**PLANNED UNIT DEVELOPMENT
& SUBDIVISION STAFF REPORT****Date: April 3, 2014****DEVELOPMENT NAME**

First Baptist Church of Tillman's Corner Subdivision

Planned Unit Development to allow multiple buildings on a single building site and Subdivision approval to combine multiple lots to create one legal lot of record.

SITE PLAN

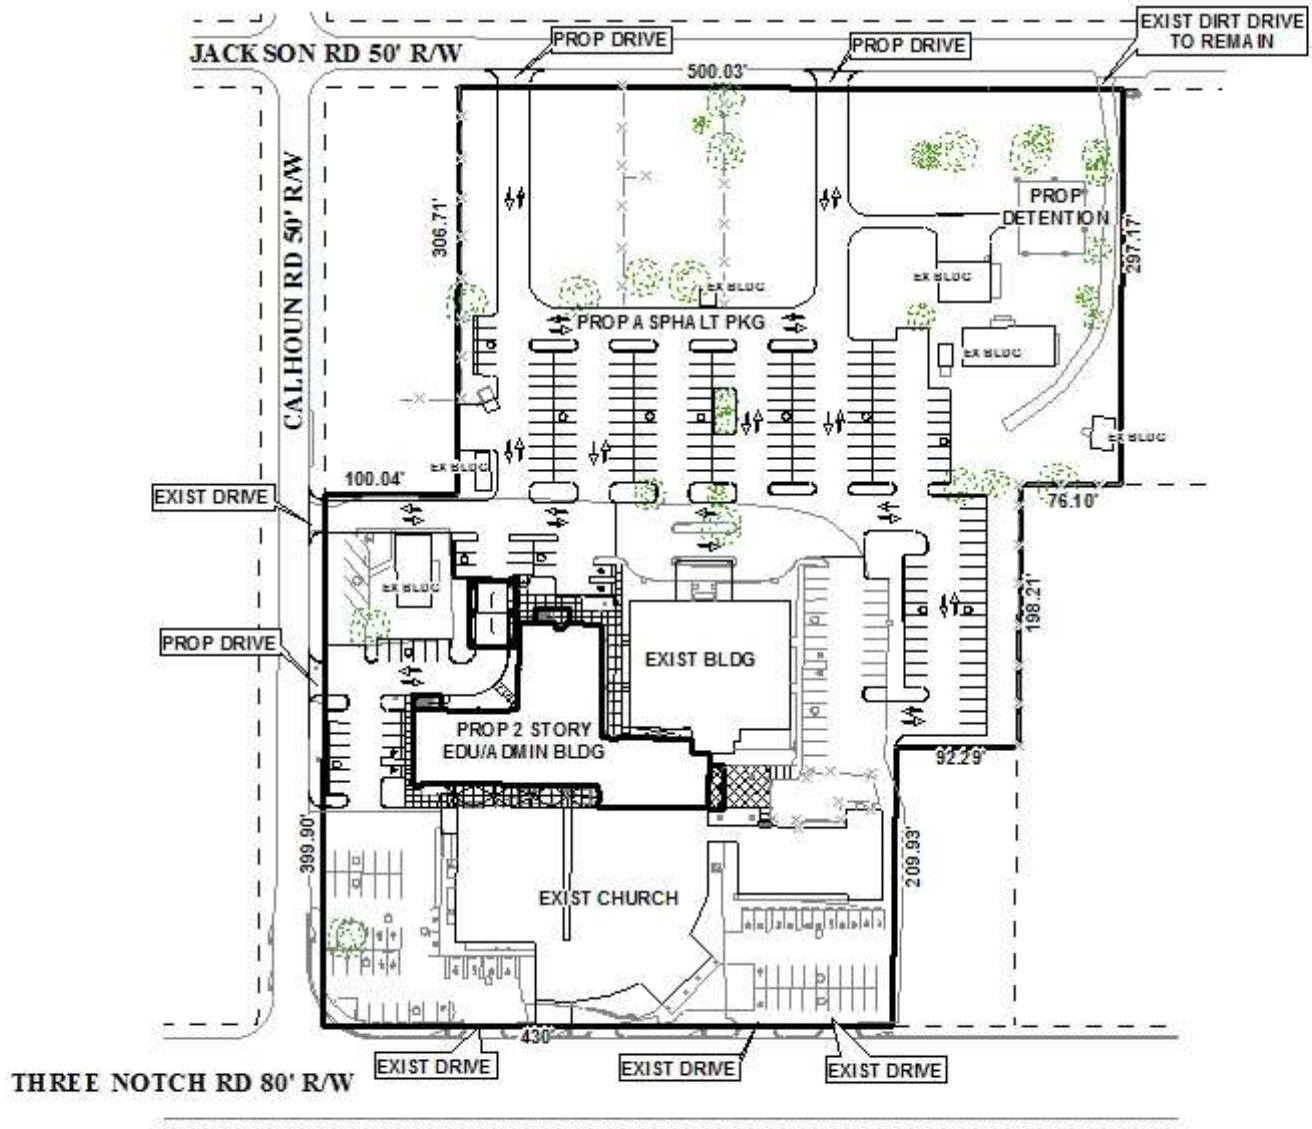
Driveway number, size, location and design to be approved by Traffic Engineering and conform to AASHTO standards. The southern most driveway on

Calhoun Road must be reduced in width, by maintaining the proposed northern radii and moving the southern radii to match the adjacent aisle width. All new on-site parking, including ADA handicap spaces, shall meet the minimum standards as defined in Section 64-6 of the City's Zoning Ordinance.

Access management is a concern due to the site's fronting 3 streets with multiple curb-cuts and existing substandard vehicle maneuverability areas. The site has 13 existing curb-cuts and as the applicant proposes to improve access, 10 curb-cuts will still remain. The southern lot line, which runs along Three Notch Road, has 4 curb-cuts and the western lot line along Calhoun Road has 3 curb-cuts, one of which appears to be over 75' \pm wide. The curb-cuts access existing and proposed parking area. It should be pointed out that some of the existing travel aisles measure only 9' \pm and, as such, Staff recommends a one-way traffic circulation if the existing parking areas are remain non-compliant. Jackson Road has 6 existing, substandard curb-cuts. The applicant proposes to eliminate 3 and retain and improve 2 of the curb-cuts. As one of the gravel drives appears to remain unimproved, the site plan should be revised to illustrate a paved drive.

The site plan illustrates several existing issues within the site. A portion of the eastern property line north of Three Notch Road appears to share access with the adjacent lot to the east, which is

not included in this request. The site plan should be revised to illustrate curbing and landscaping along the eastern property line to prevent vehicular access between the two lots. If the applicant desires to continue a shared access, the lot to the east should be included in the PUD request.

All proposed parking areas appear to be compliant in terms of travel aisle width and parking stall dimensions; however, the site plan does not depict any proposed lighting. Any new lighting on the site will have to comply with the requirements of Sections 64-4.A.2., 64-6.A.3.c., and 64-6.A.8. of the Zoning Ordinance. A note reflecting this requirement should appear on the site plan, and photometric plans will be required at the time of permitting.

It should be pointed out that the site plan does not depict any sidewalks along any street frontages. The site plan should be revised to illustrate sidewalks along all street frontages or the applicant should submit a Sidewalk Waiver request.

Also, the site plan does not depict a residential buffer nor frontage trees and landscaping. A 10' residential buffer should be required along the northwestern lot line where the property abuts an adjacent residentially developed lot and along the northeastern lot line where the property abuts a vacant lot which may be developed residentially. The site plan should be revised to illustrate the buffer in compliance with Section 64-4.D.1. of the Zoning Ordinance and illustrate and quantify full compliance with the tree and landscaping requirements of Section 64-4.E. of the Zoning Ordinance.

The site plan depicts a dumpster and it should be noted that all dumpsters shall be in compliance with Section 64-4.D.9. of the Zoning Ordinance to include being enclosed on at least three sides and connected to sanitary sewer.

- 1) Provision of a written statement that the owner will petition for inclusion or exclusion from the city;
- 2) Revision of the site plan to depict a permanent closure of the vehicular access to the adjacent property to the east with curb and landscaping, or the revision of the PUD request to include the lot to the east and shared access;

- 3) Revision of the site plan to comply with Traffic Engineering Comments: *(Driveway number, size, location and design to be approved by Traffic Engineering and conform to AASHTO standards. The southern most driveway on Calhoun Road must be reduced in width, by maintaining the proposed northern radii and moving the southern radii to match the adjacent aisle width. All new on-site parking, including ADA handicap spaces, shall meet the minimum standards as defined in Section 64-6 of the City's Zoning Ordinance.)*;

- 4) Coordination with Staff to improve onsite traffic flow and revision of the site plan to illustrate one-way traffic flow with compliant 12' travel aisles/vehicular maneuverability area where travel aisles are less than 24';

- 5) Revision of the site plan to illustrate proposed lighting along with a note stating any new lighting on the site will have to comply with the requirements of Sections 64-4.A.2., 64-6.A.3.c., and 64-6.A.8. of the Zoning Ordinance;

- 6) Depiction of a paved driveway in the northeast corner of the lot if the applicant desires to retain the curb-cut;
- 7) Depiction of sidewalks on the site plan along all street frontages or the submission of a Sidewalk Waiver request;

- 8) Depiction of a 10' residential buffer on the site plan along the northeastern and northwestern lot lines in compliance with Section 64-4.D.1. of the Zoning Ordinance;

- 9) Revision of the site plan to illustrate and quantify full compliance with the tree and landscaping requirements of Section 64-4.E. of the Zoning Ordinance;

- 10) Revision of the site plan to include a note stating that all common and detention areas shall be maintained by the property owners;
- 11) Revision of the site plan to reflect sufficient dedication to provide 30' as measured from the centerline of both Calhoun and Jackson Roads;

- 12) Revision of the site plan to depict a corner radius in compliance with Section V.D.6. of the Subdivision at the intersection of Calhoun and Three Notch Roads;

- 13) Revision of the 25' minimum building setback line on the site plan to reflect dedication and corner radius;
- 14) Revision of the site plan to depict a 35' minimum building setback line along Three Notch Road; and

- 15) Depiction of a dumpster on the site plan in compliance with Section 64-4.D.9. of the Zoning Ordinance.
